**Town of Surfside
SPECIAL PLANNING & ZONING BOARD
AGENDA**

February 11, 2021 – 6:00 p.m.

To: Planning and Zoning Board
Thru: Andrew Hyatt, Town Manager
From: Walter Keller, PE, AICP., Town Consultant Planner
Marlin Engineering, Inc.
CC: Jason Greene, Assistant Town Manager
Lillian Arango, Town Attorney
Date February 1, 2021
RE: 9133 – 9149 Collins Avenue – Seaway Condo Acquisition LLC – Site Plan Amendment

SHEET NO. A4.02

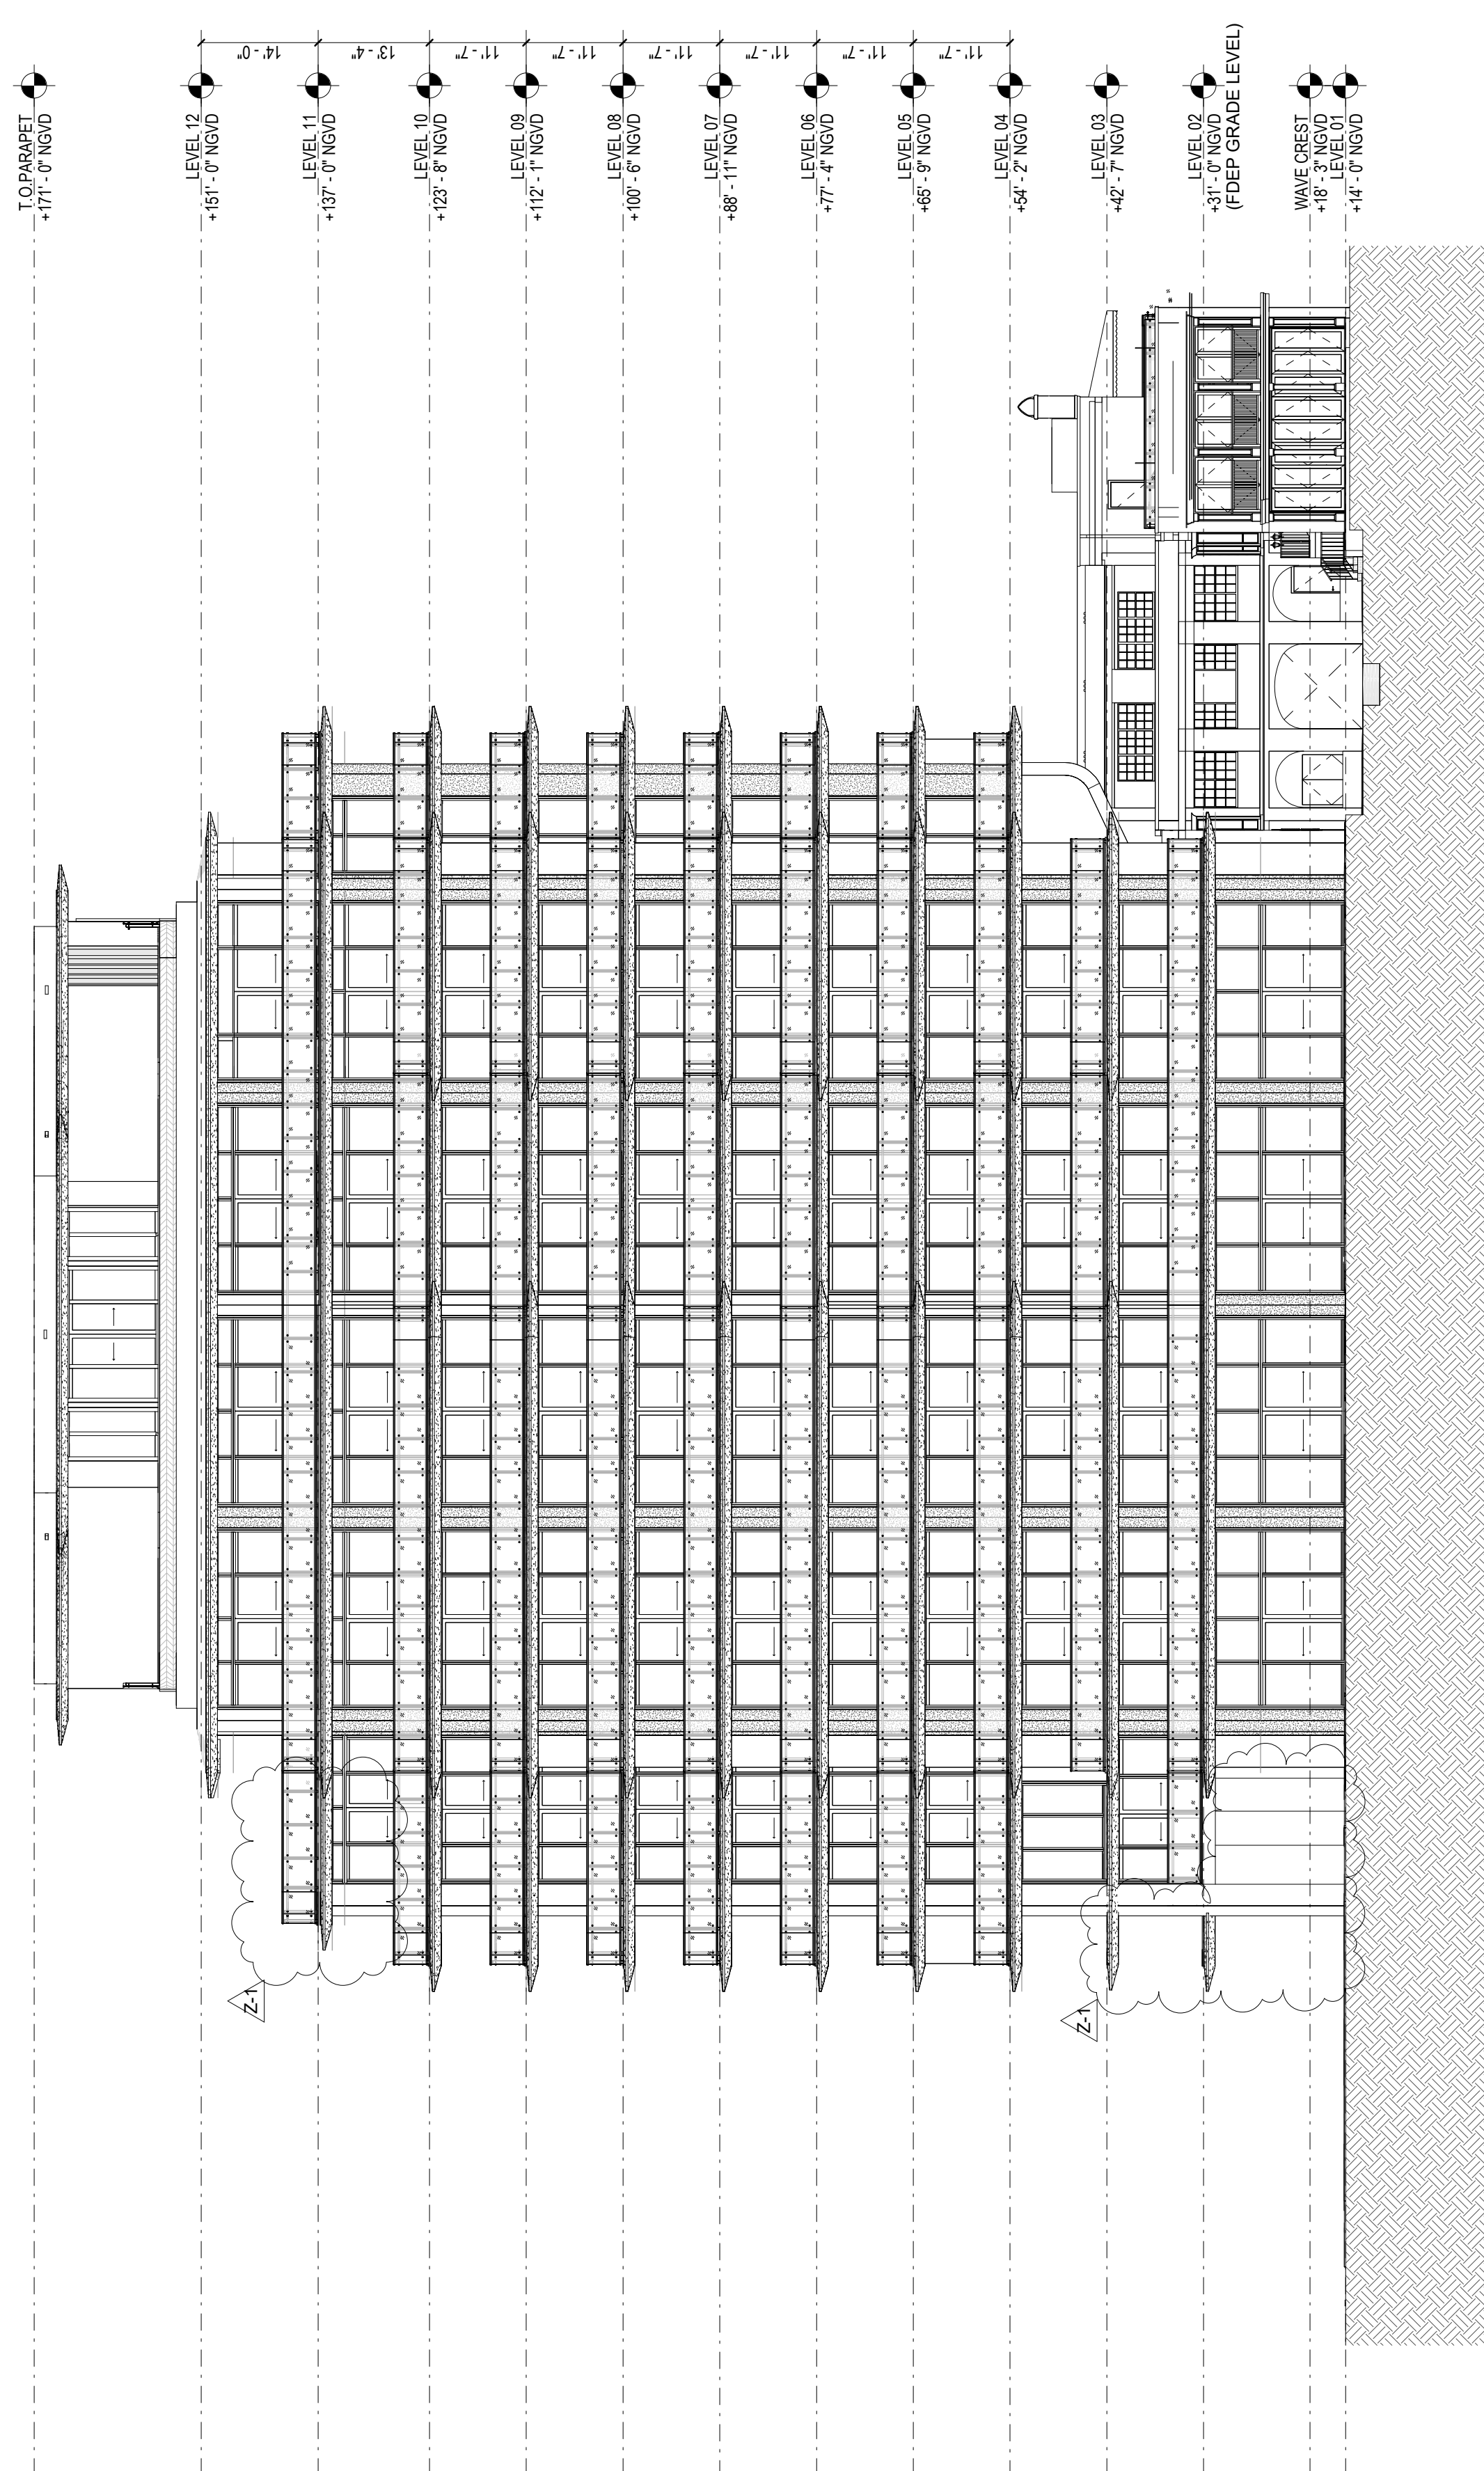
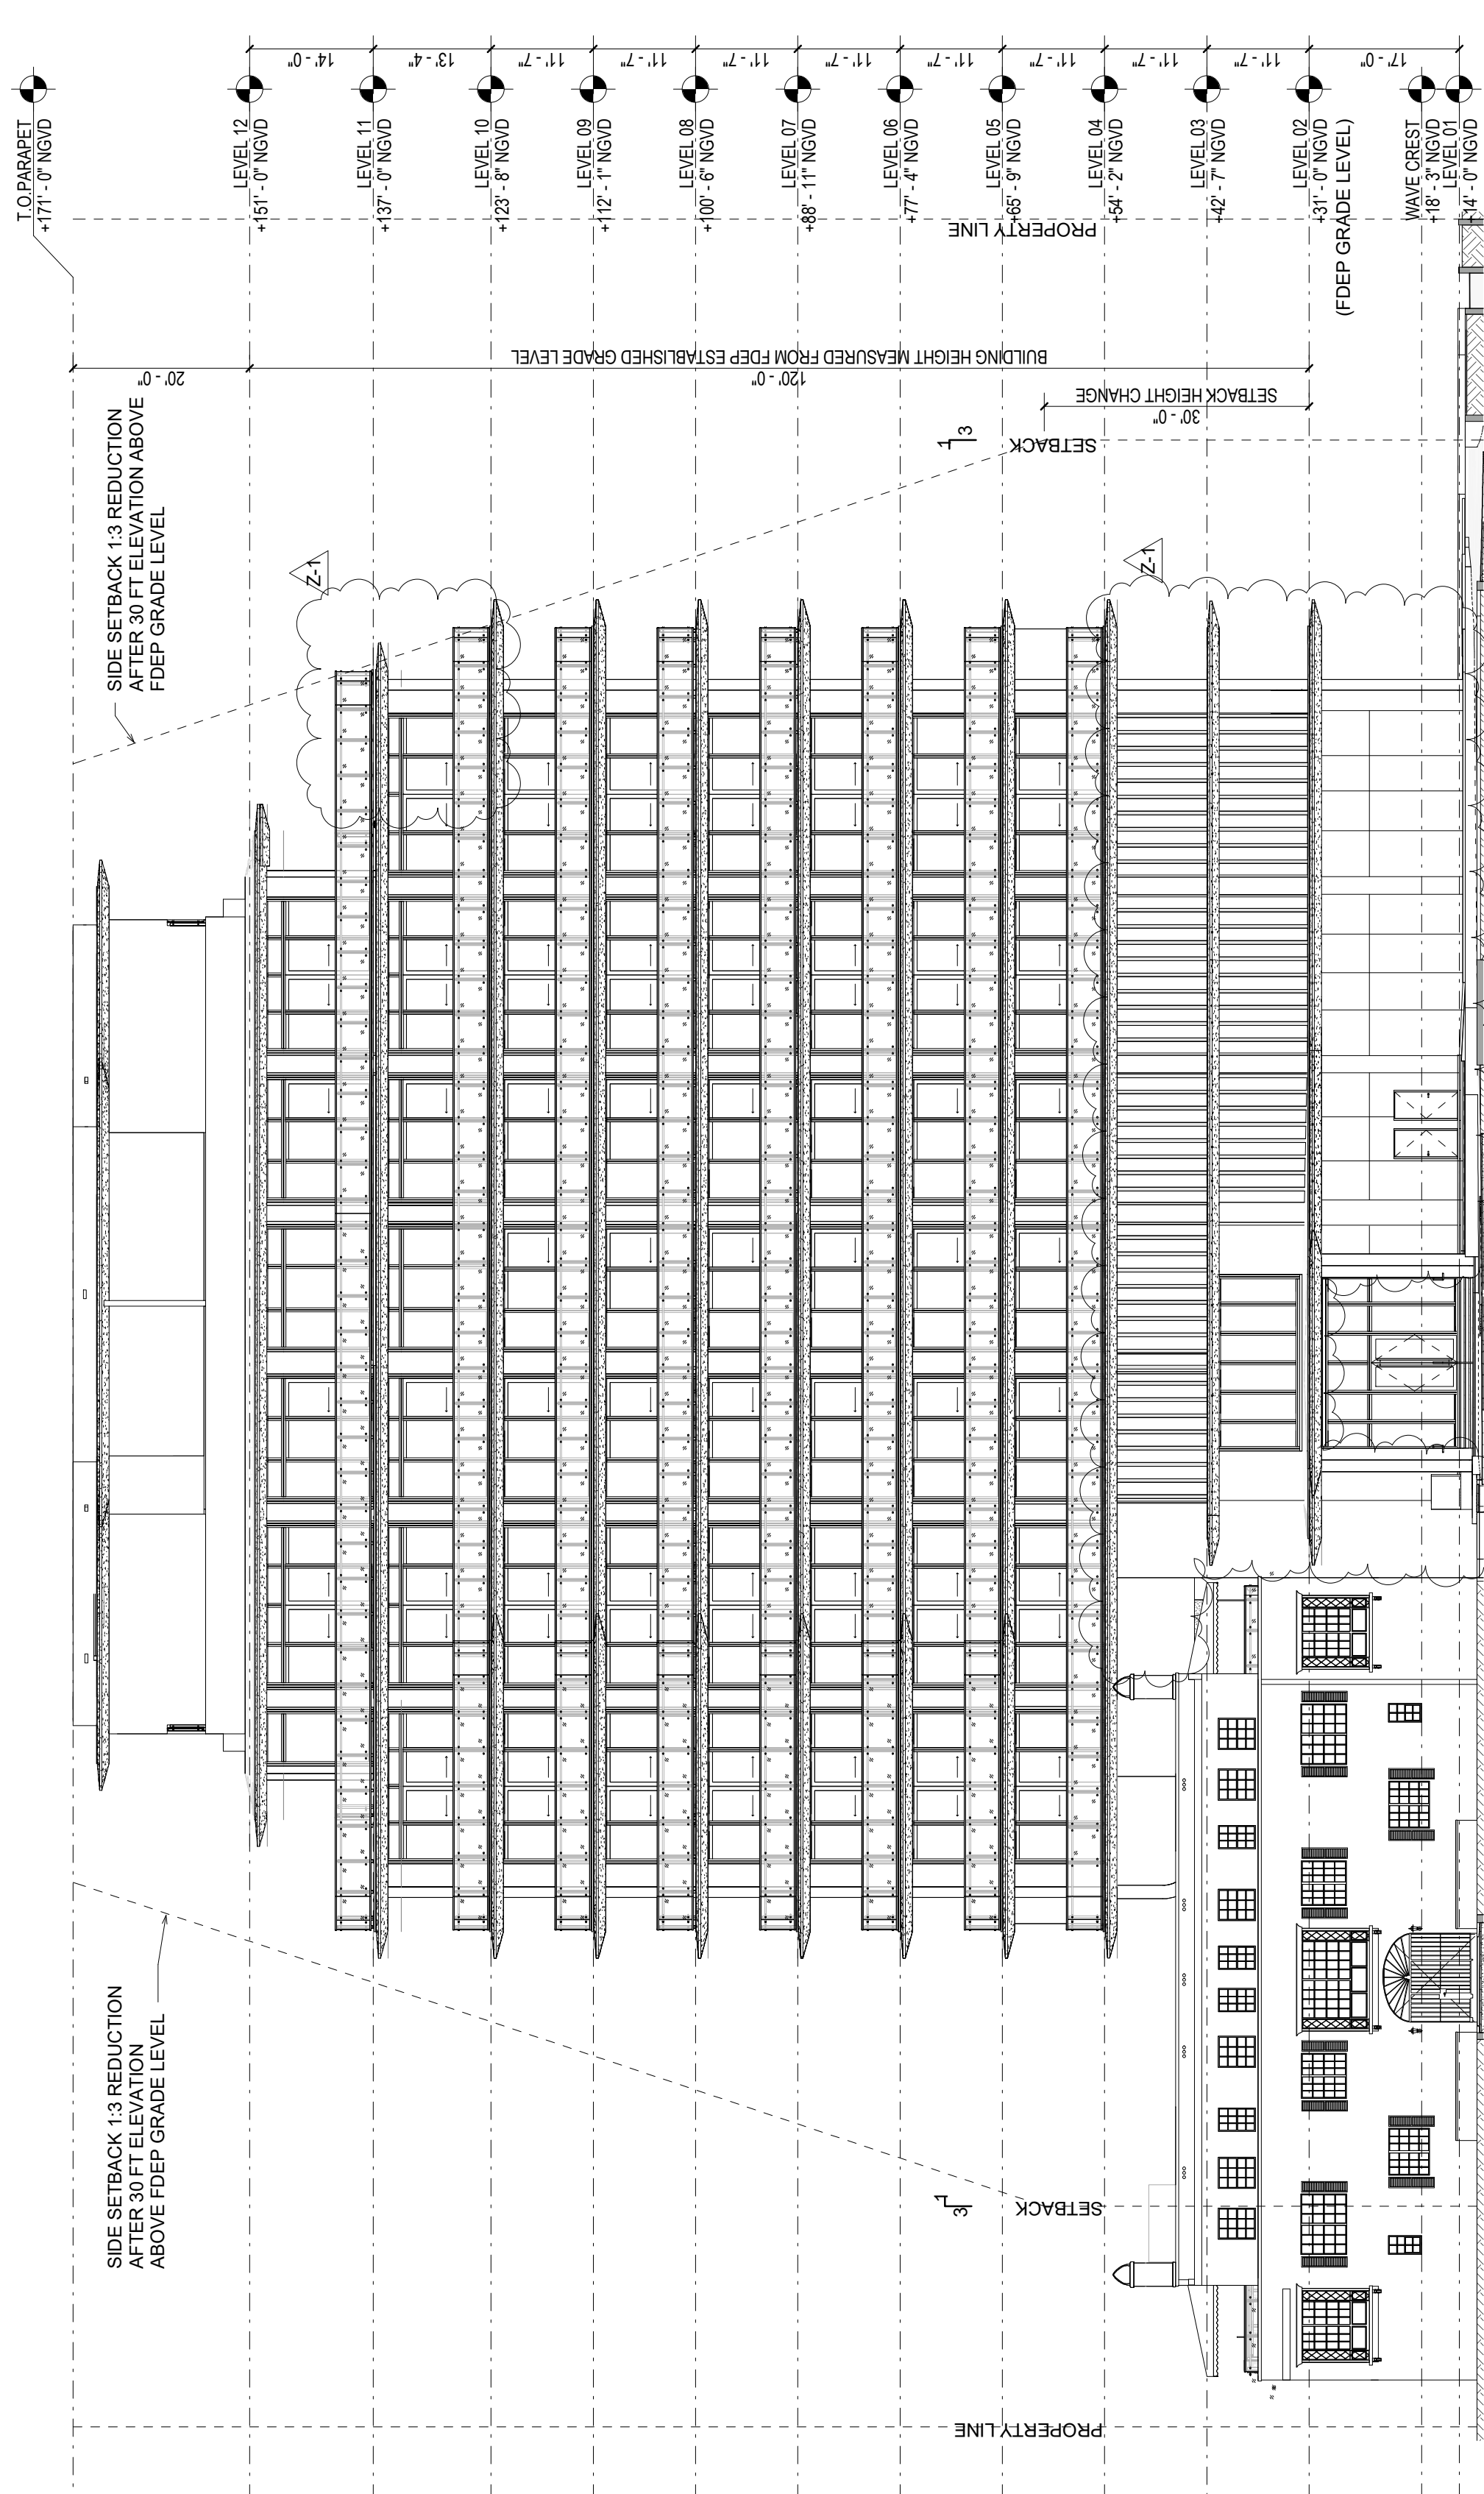
As shown on Amended Sheets A0.00, A1.03, A1.04, A1.05, A2.00, A3.00, A3.02, A4.01, and A4.02, Applicant’s new architect of record, ODP Architects, has proposed minor exterior design enhancements that include removing “notches” in balcony design on the north and south sides of levels 2 through 12; extending a balcony on the 11th level to make the design consistent with lower typical floors; and adding decorative stone louvers and balconies on the 2nd and 3rd levels to provide privacy for unit owners and hotel units. No amendments are proposed to the exterior of the historic Seaway building.

PROPOSED SITE PLAN

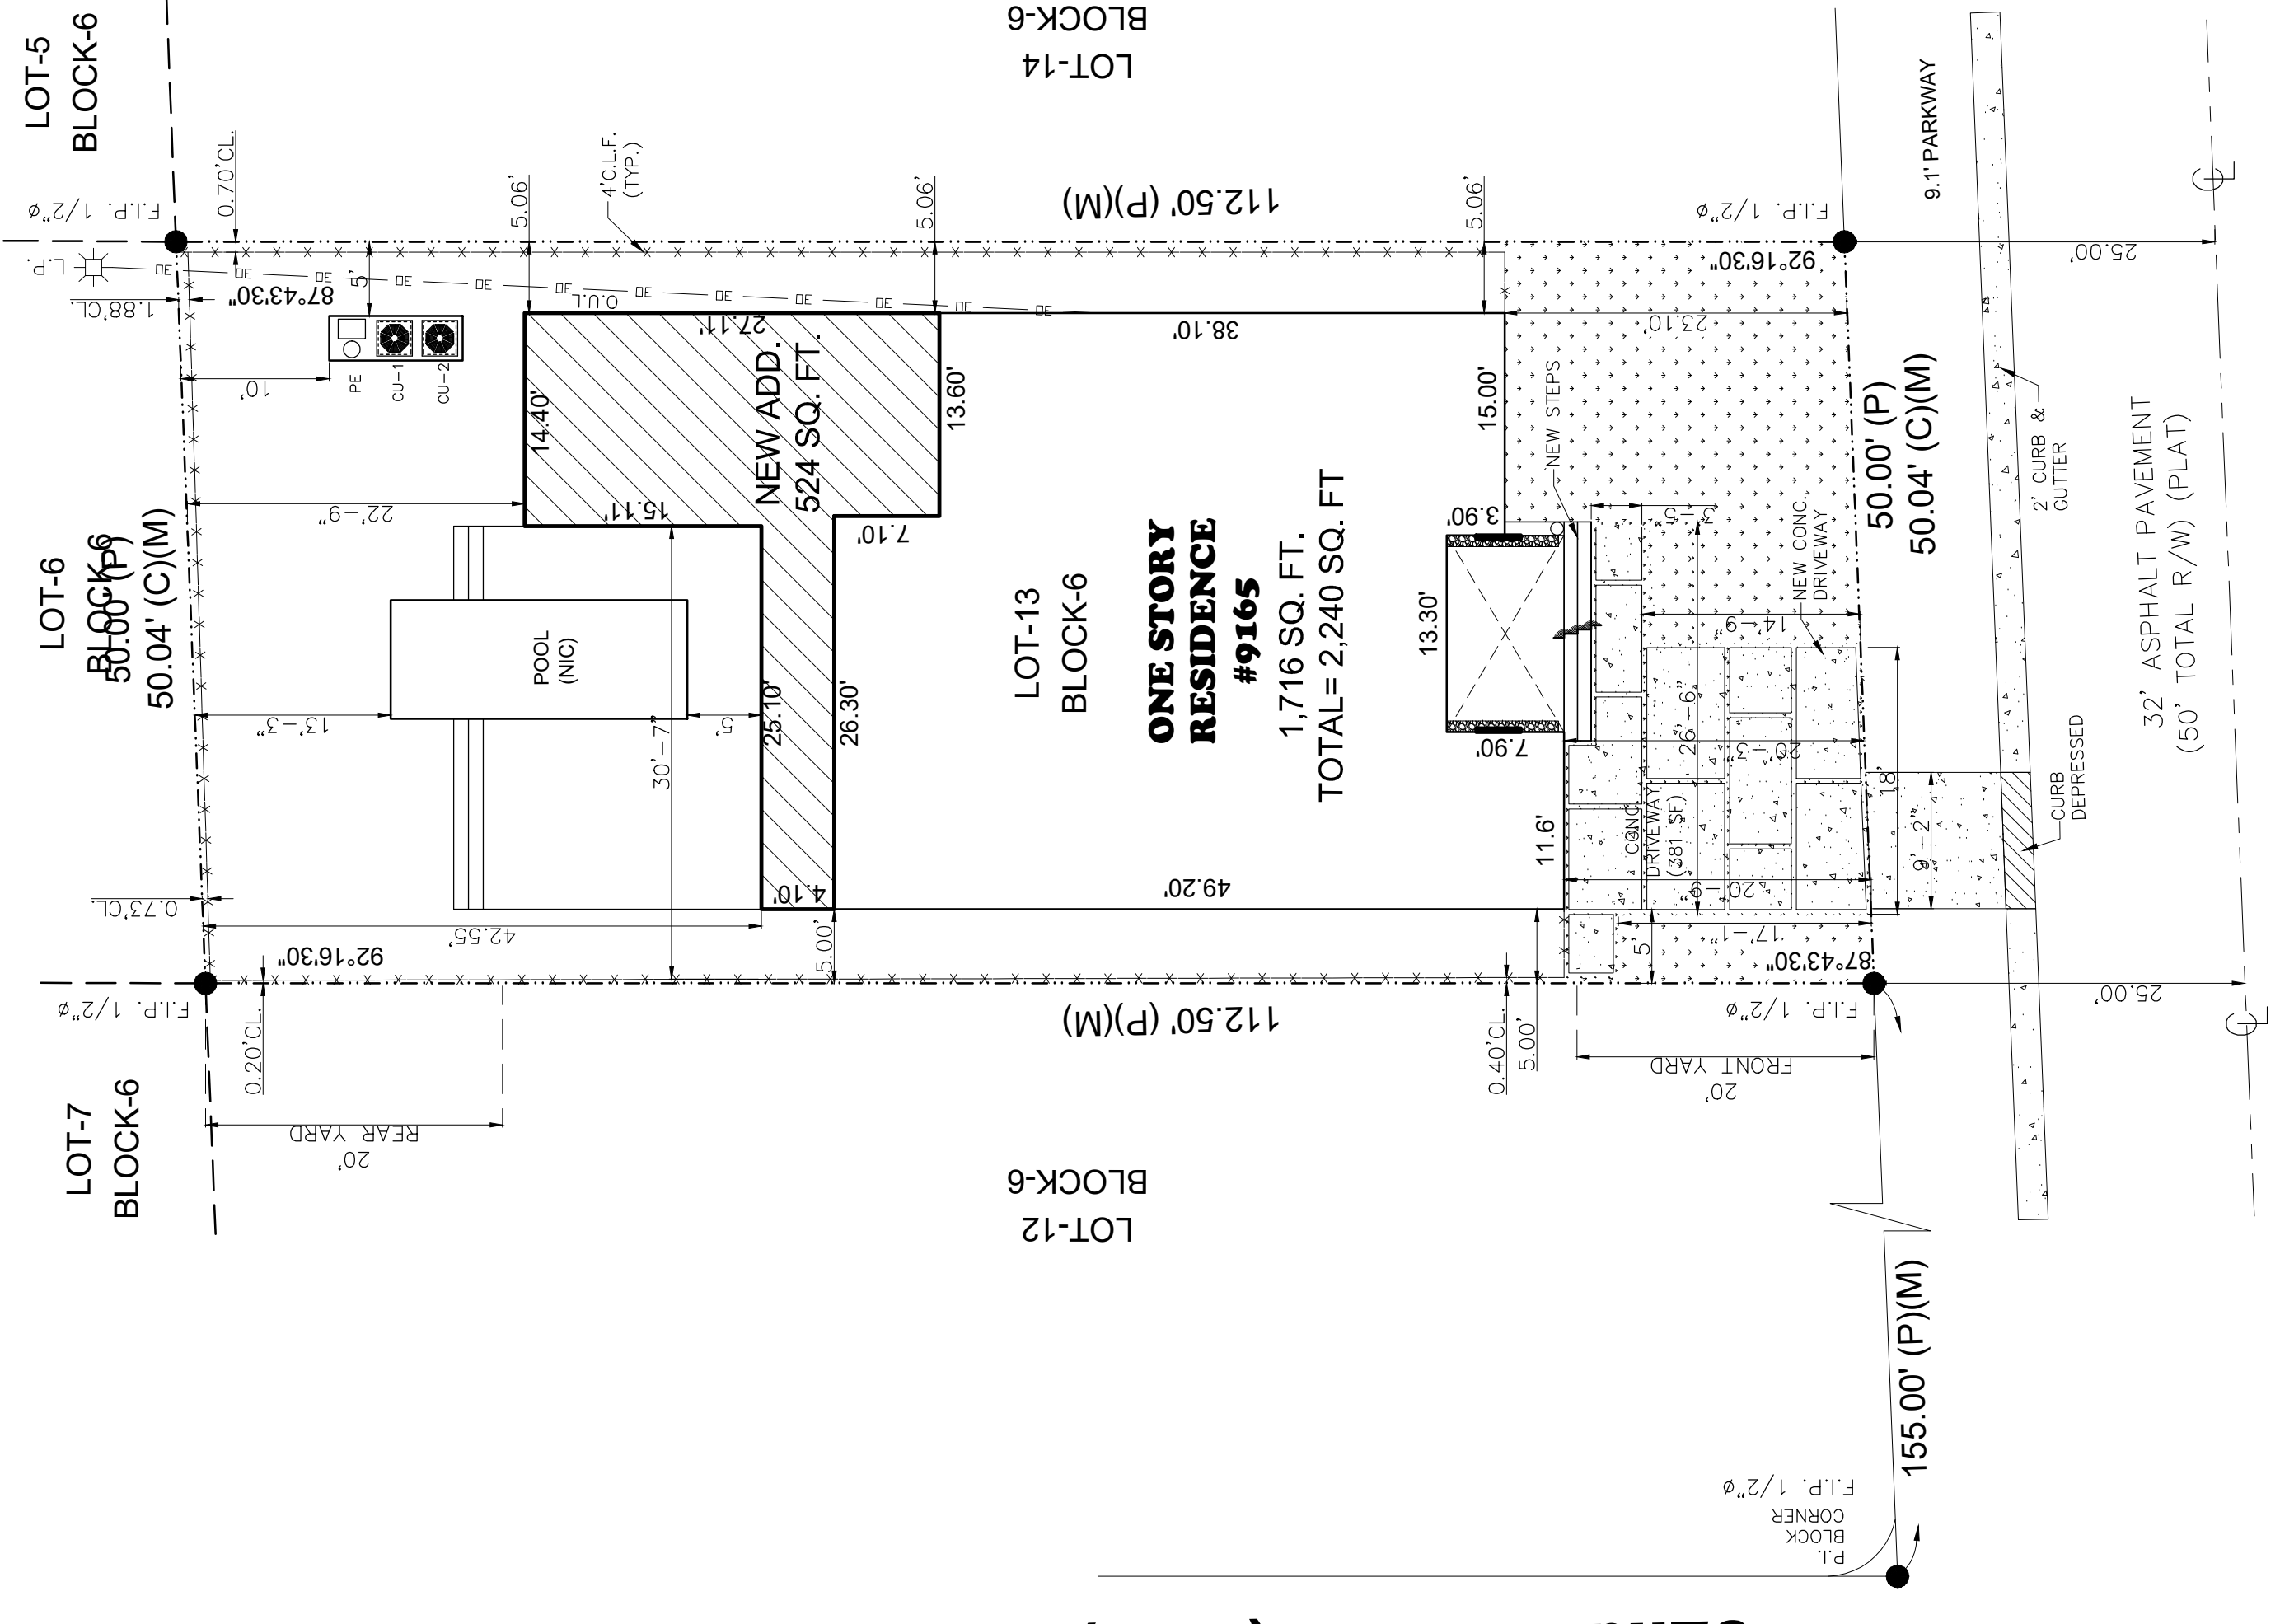
The Applicant submitted additional information to address pervious area, compliance with front and rear yard landscape area and modifications of the front yard hardscape. Additional revisions were made to revise the front elevation in the vicinity of the front door – porch area.
